SAND CREEK RESTORATION

PCD PROJECT NUMBER: CDR-20-004 PUBLIC IMPROVEMENT CONSTRUCTION PLANS

ERD STORMWATER REVIEW COMMENTS
 IN ORANGE BOXES WITH BLACK TEXT

GRouted STEPPED BOULDER DROP #5 DETAIL
PLAN VIEW
SCALE: 1"=20'

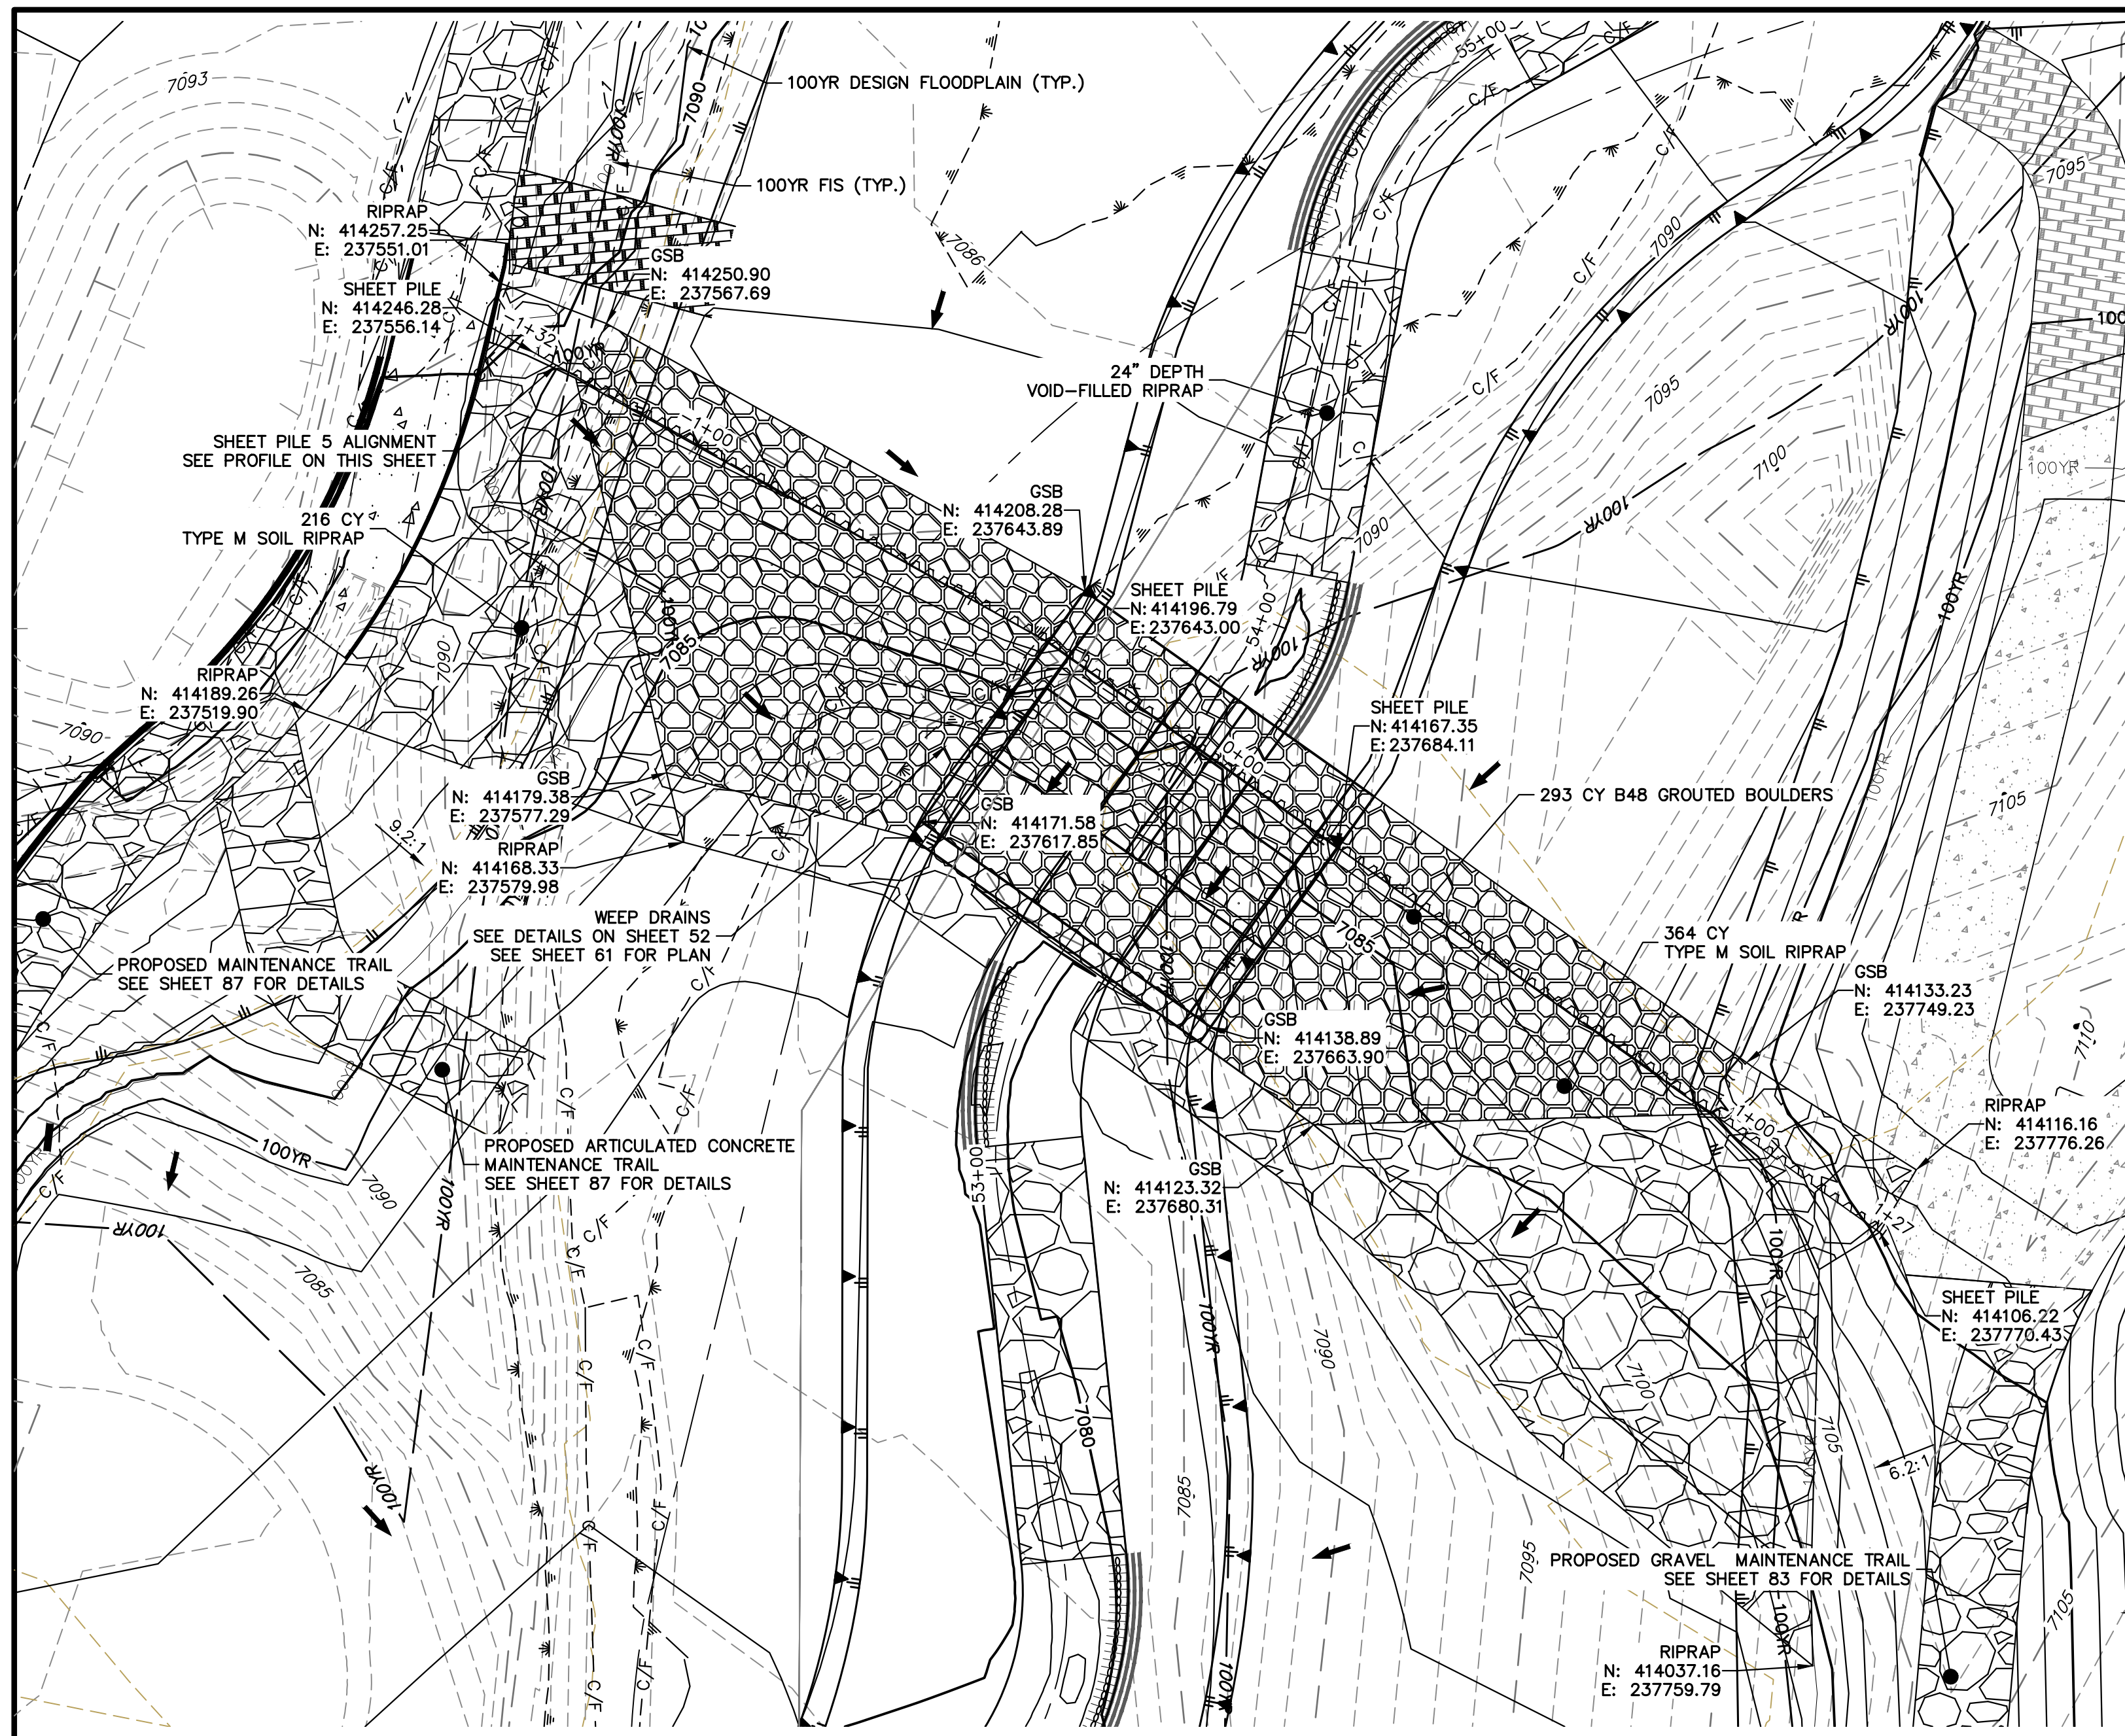
Label slopes,
grade breaks,
riprap (more
detail is needed)
